#### SUBDIVISION REVIEW SHEET

CASE NO.: C8J-2021-0080.0ACOMMISSION DATE: May 24, 2022SUBDIVISION NAME: Whisper Valley Multifami> Parcel 65 Preliminary PlanADDRESS: 17001 E Braker LaneAPPLICANT: Club Deal 120 Whisper Valley, L.P.AGENT: Land Dev Consulting (Michael Giannetta)ZONING: Whisper Valley PUDMEIGHBORHOOD PLAN: N/AAREA: 16.2 acresCOUNTY: TravisMATERSHED: Gilleland CreekJURISDICTION: Limited Purpose

CITY OF AUSTIN – TRAVIS COUNTY – SINGLE SUBDIVISION OFFICE SUBDIVISION APPLICATION – MASTER COMMENT REPORT

FULL AND PARTIAL SEDIMENTATION/FILTRATION POND, BIOFILTRATION POND, AND **VEGETATIVE FILTER STRIP CALCULATIONS** FOR PRELIMINARY PLANS AND FINAL PLATS Whisper Valley Multifamily Parcel 65 Preliminary Plan ROW (Lilt Drive), C8J-2021-0066

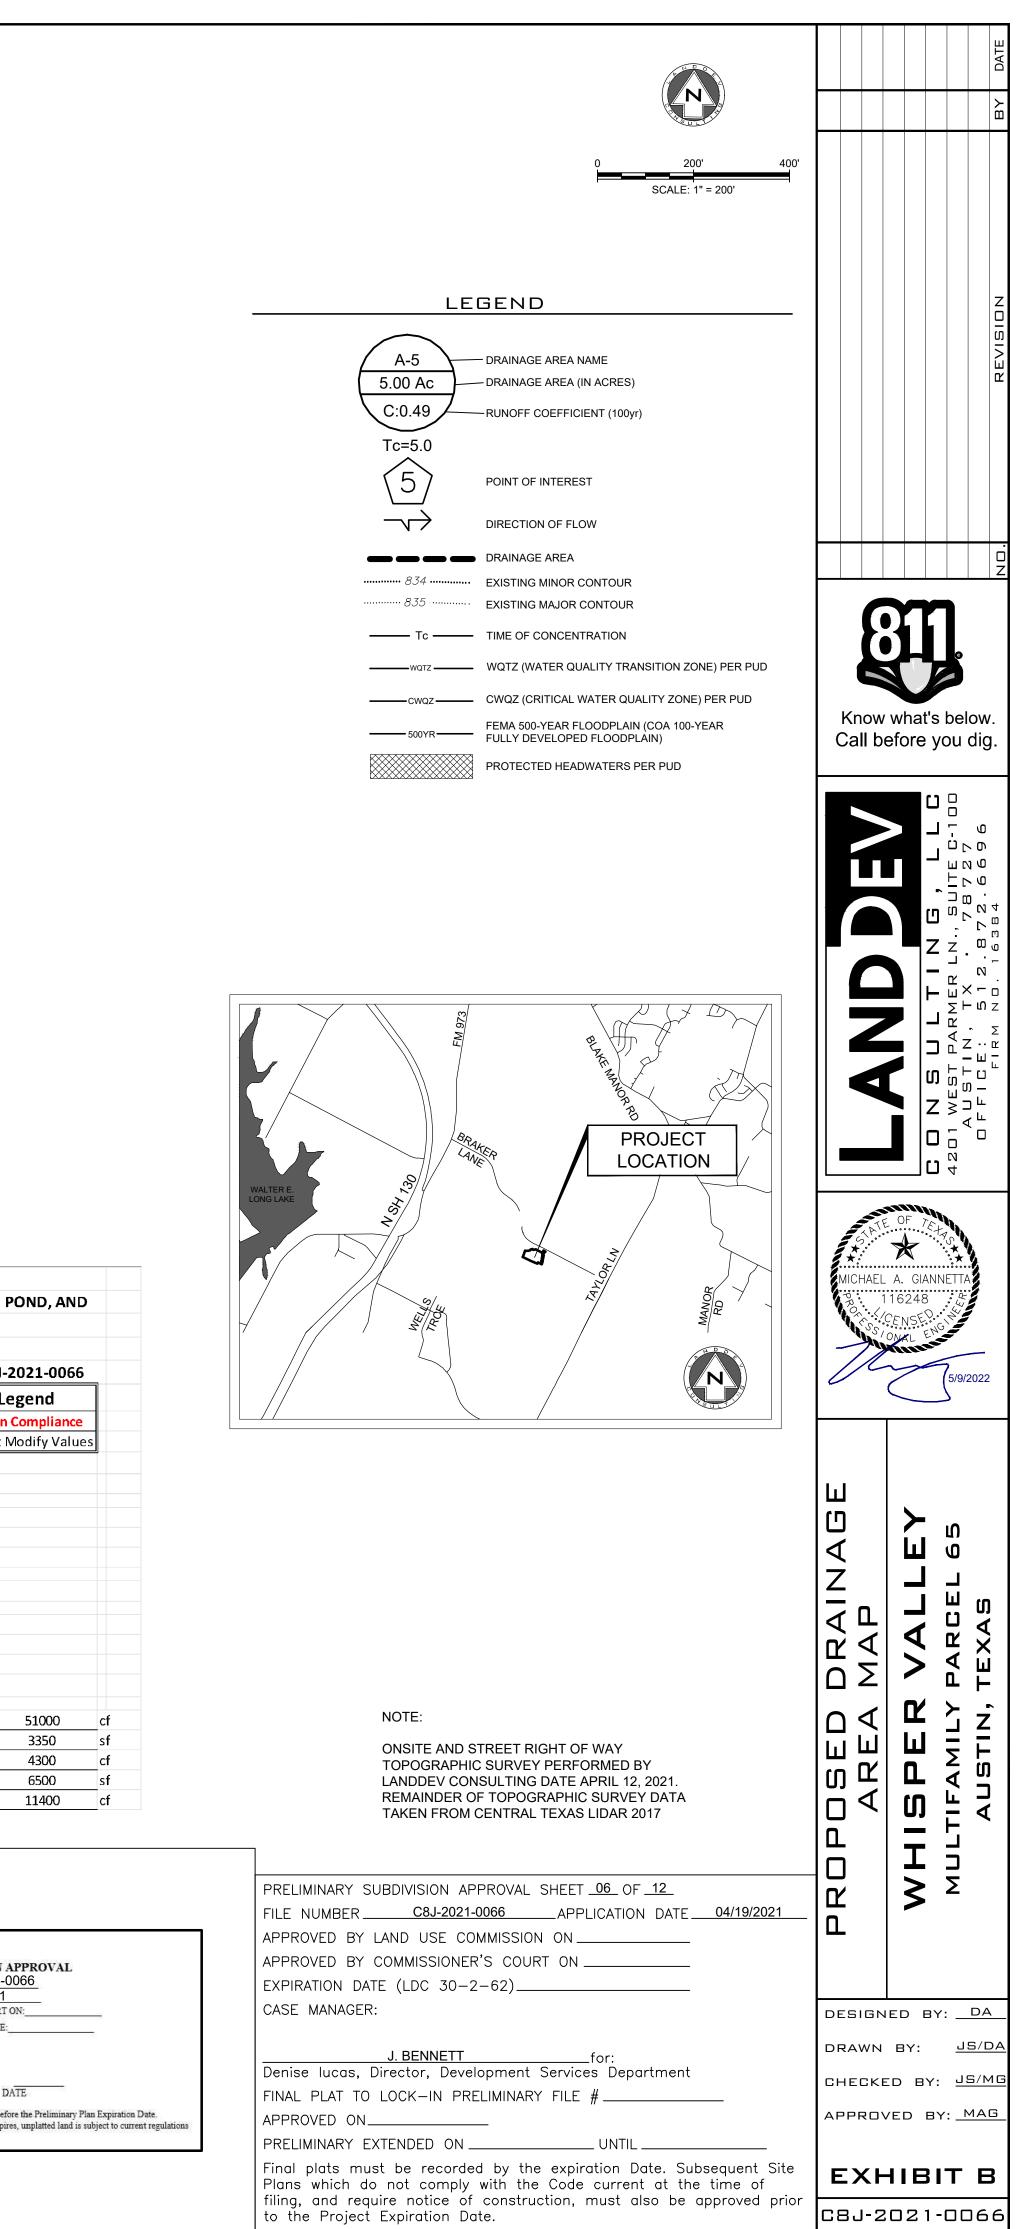
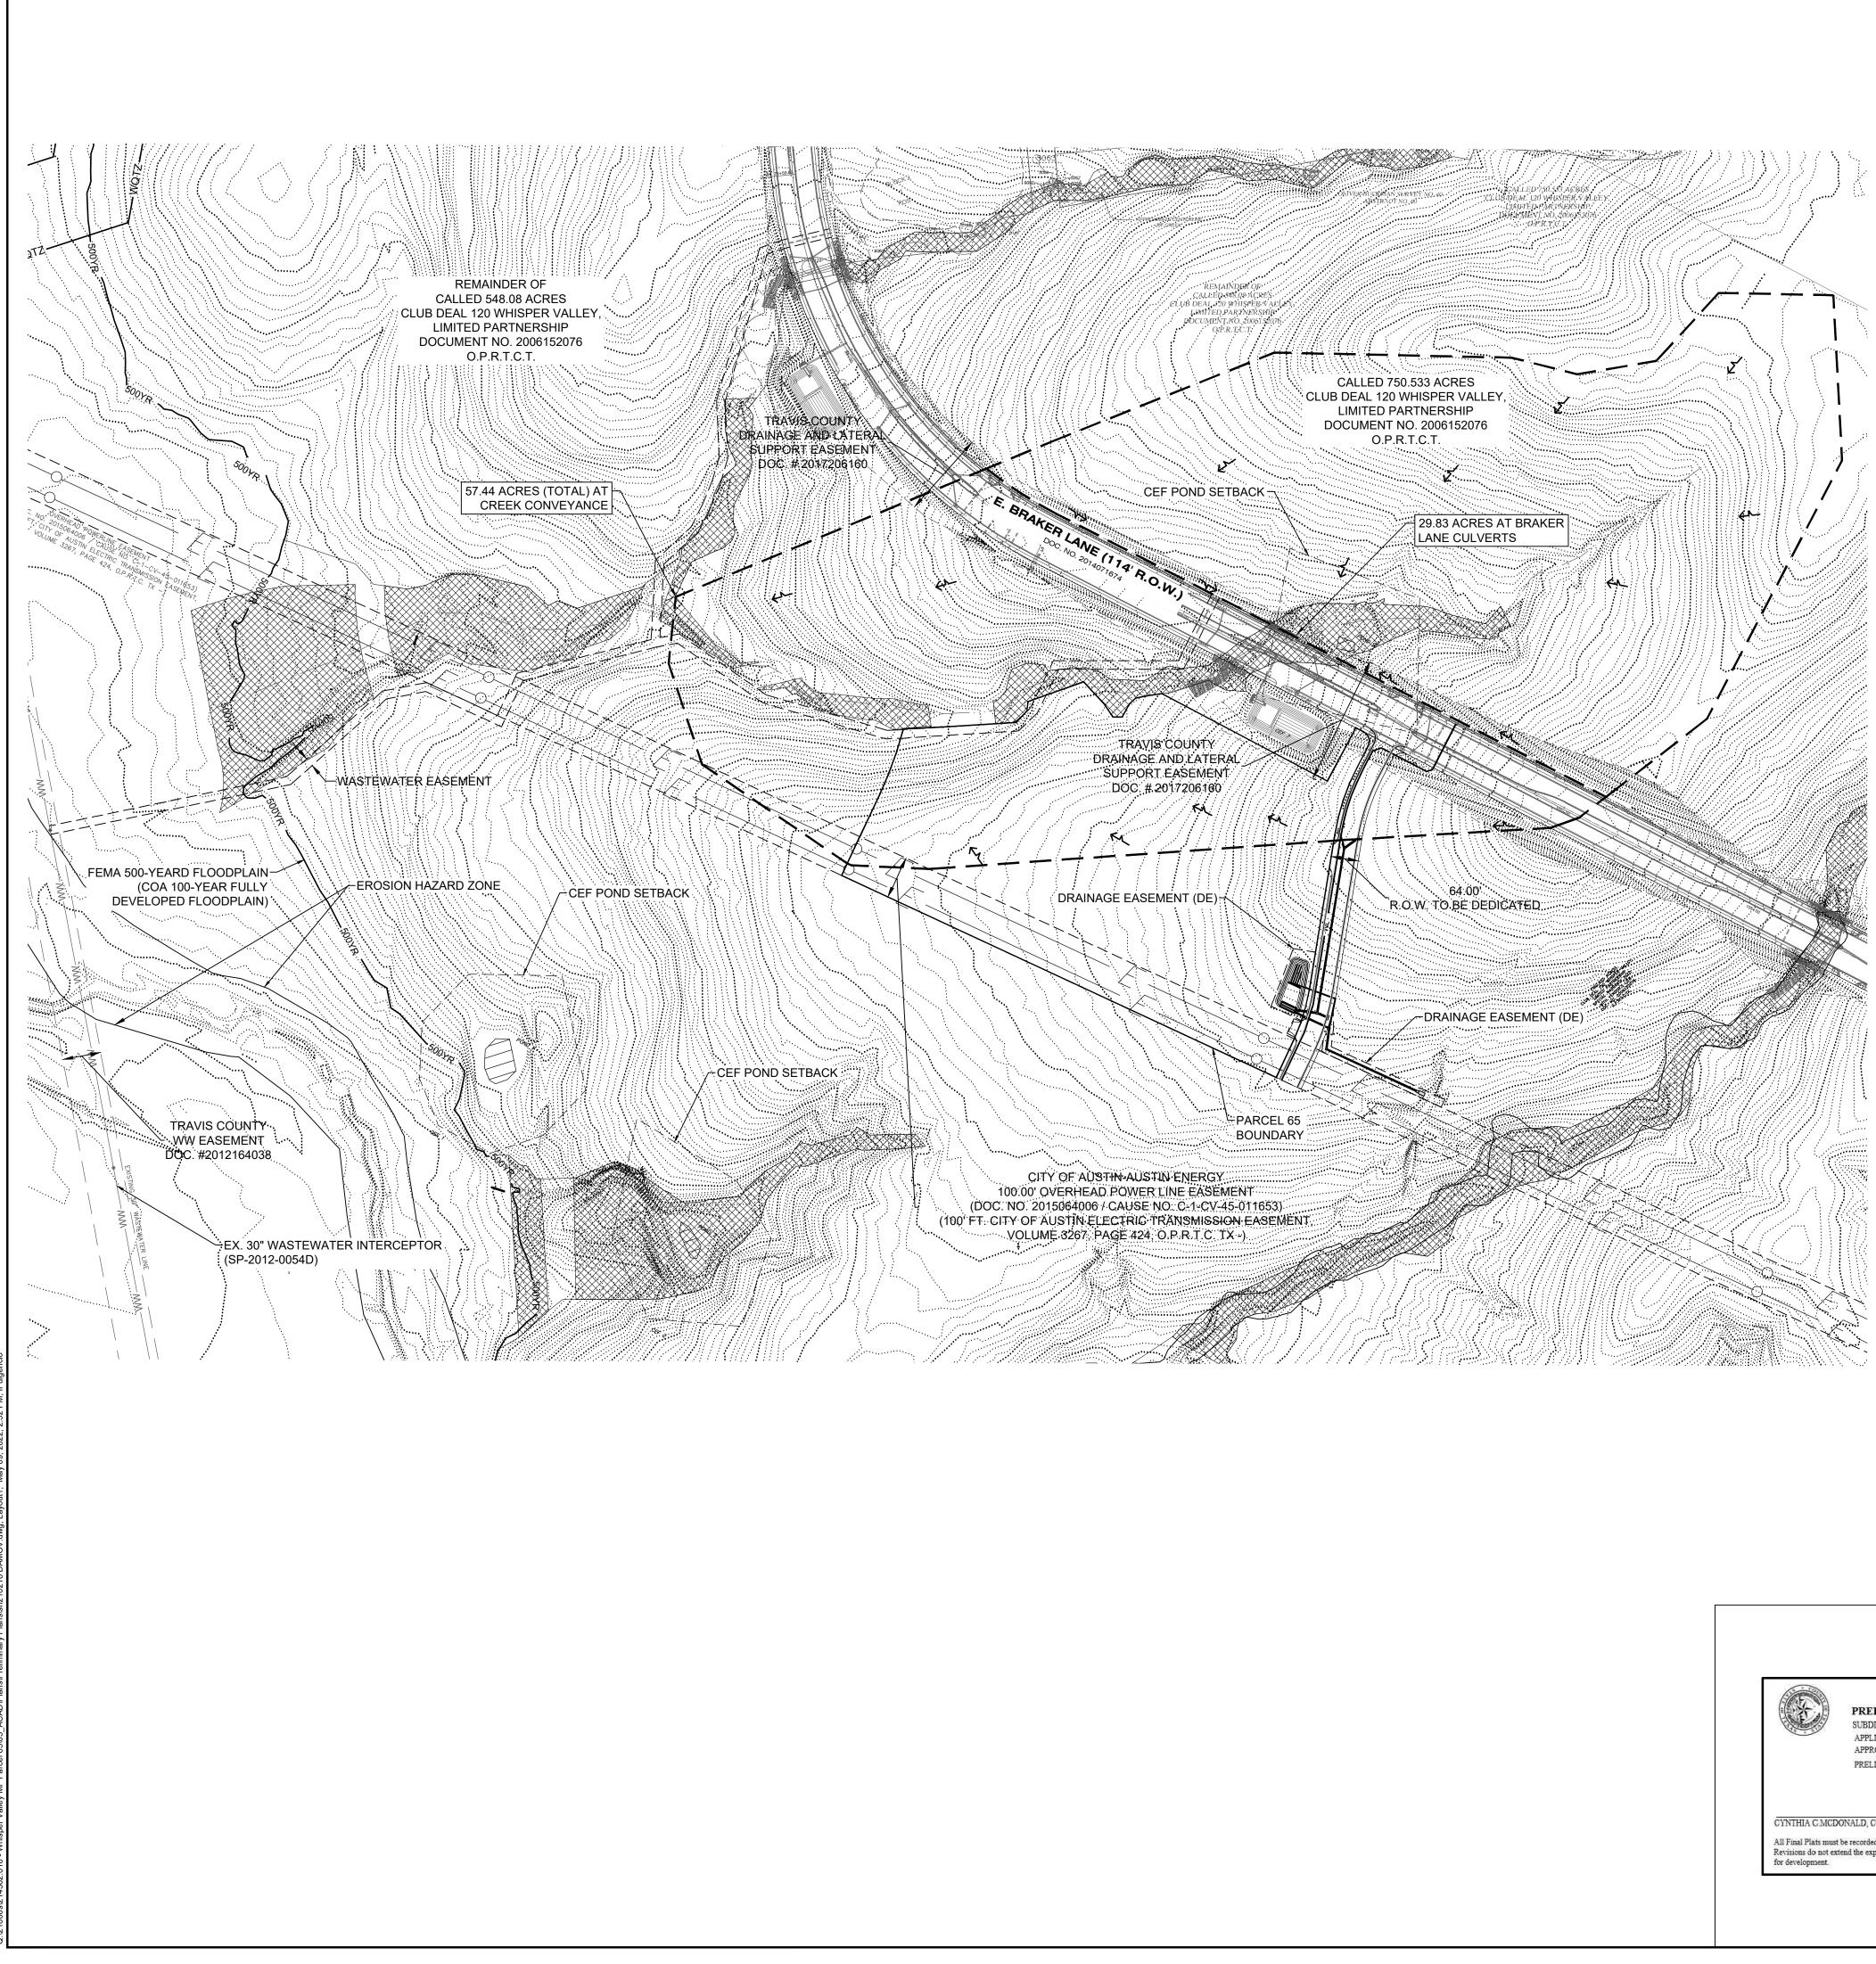
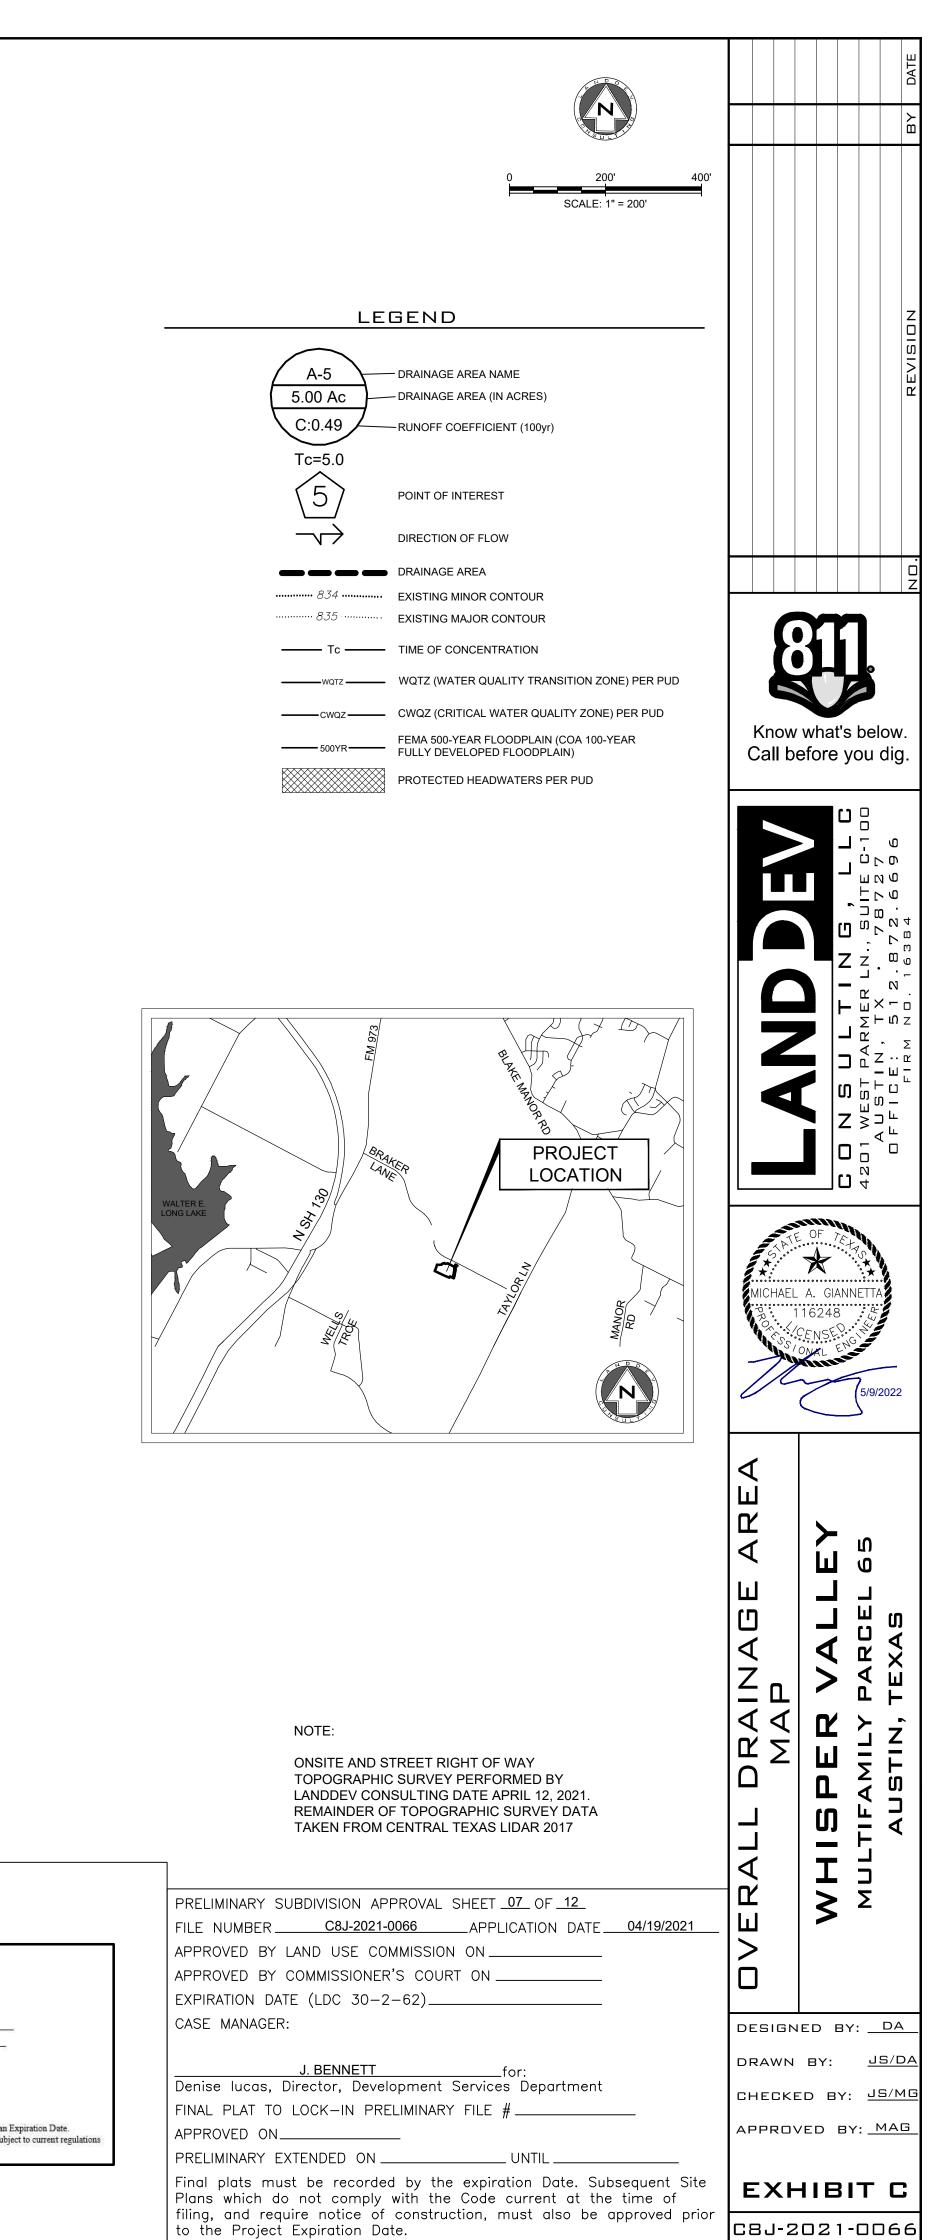
- WQ 3. Please clarify how runoff from Drainage Area P-1 is treated for water quality purposes. [LDC 30-5-211; ECM 1.9.2]
   U1 Comment Cleared.
- WQ 4. Per the Appendix R-6 table provided, the provided water quality volume (4,000 cf) is less than the required volume (6,011 cf). Please demonstrate compliance. [ECM 1.6.2(A)]
   U1 Comment Pending: Verify data shown in the R-1 Table. The peak flow rates provided are not correlated with the drainage area to control. The required water quality volume is greater than the water quality volume provided. Demonstrate that the pond areas and pond volumes are reflective of the sizes provided in the R-1 Table. A full sedimentation/biofiltration pond is required per ECM 1.6.2.A.
